**Comment Letter A13—San Francisco Bay Regional Water Quality Control Board,  
Keith E. Roberson (letter dated November 23, 2015)**

**Subject: City Place Santa Clara Project – Draft Environmental Impact Report (DEIR)**

**From Figure 3.9**

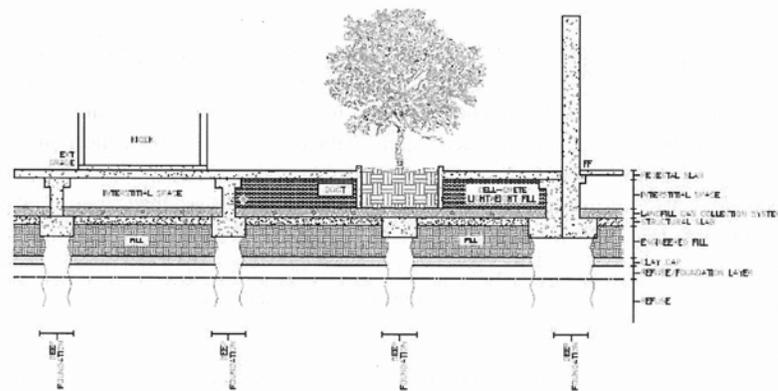
Regional Board staff is concerned about the use of irrigated landscape and the potential for infiltration into the landfill or the landfill gas venting system as shown below.

This figure shows an irrigated tree planter directly overlies the landfill gas collection system layer. A pervious planter bottom would result in flooding of the landfill gas venting system. It is

A13.14 | unclear how an impervious bottom would be monitored for potential breaches (or whether the  
Cont. | planter could drain properly).

A13.14 *The commenter expressed concern that a leak or rupture of the landfill gas venting lines could occur due to flooding associated with irrigation of stormwater treatment measures (trees/planters) or a rupture in associated water lines. The commenter states that the flooding may impact the ability to detect or vent methane in that area, and that the ability to monitor or implement mitigation measures for this type of incident is unknown.* The Project would be designed so as to prevent leakages or other interactions with the underlying landfill. Impermeable caps and liners would be placed along the top and bottom of the entire landfill area. For example, geomembrane or an equivalent system with low permeability to landfill gas would be installed between the concrete floor slab of the building and subgrade. According to conceptual design plans, all stormwater treatment measures and landscape planters on the podium would include an impermeable liner (on bottom and sides) that would prevent any leaks or ruptures into the landfill and structures. There would also be perforated underdrain piping connected to solid piping at the exit of the treatment measure/planter solid piping that would connect to the storm drain infrastructure at manholes where leak monitoring can be performed. Below the bottom of the treatment measures/planters is another impermeable membrane, which is part of the landfill gas collection system installed on the podium structure. A drainage system would be installed above the top of the podium structure to allow for collection and drainage of stormwater that percolates through pavement sections and landscape areas. During the preparation of specific designs for each development phase, there would be sufficient detail about these systems to conduct a detailed analysis to evaluate and address seismic effects on these systems. The majority of the domestic water system would be constructed on a structural slab supported on deep foundations. The pipes will be made of High Density Polyethylene (HDPE) pipe, which is durable and flexible against the potential effects of ground movement from settlement and earthquakes. The HDPE pipe would be embedded in compacted granular fill, which allows for more flexibility in movement in the event of an earthquake.

The following paragraph has been added after the third bullet in Mitigation Measure HAZ-4.4 (*Landfill Gas Monitoring and Control System Maintenance*) on page 3.11-32 of the Draft EIR in Section 3.11, *Hazards and Hazardous Materials*:

In the event of an earthquake or other event that could cause a rupture or leak from overlying stormwater treatment measures (i.e., planters, vegetated areas), the landfill gas venting pipes shall be inspected at access ports within 24 hours of the event for leaks, ruptures, or any other conditions. Access ports shall be installed at select locations, to provide full coverage of the system based on system design and access constraints, within
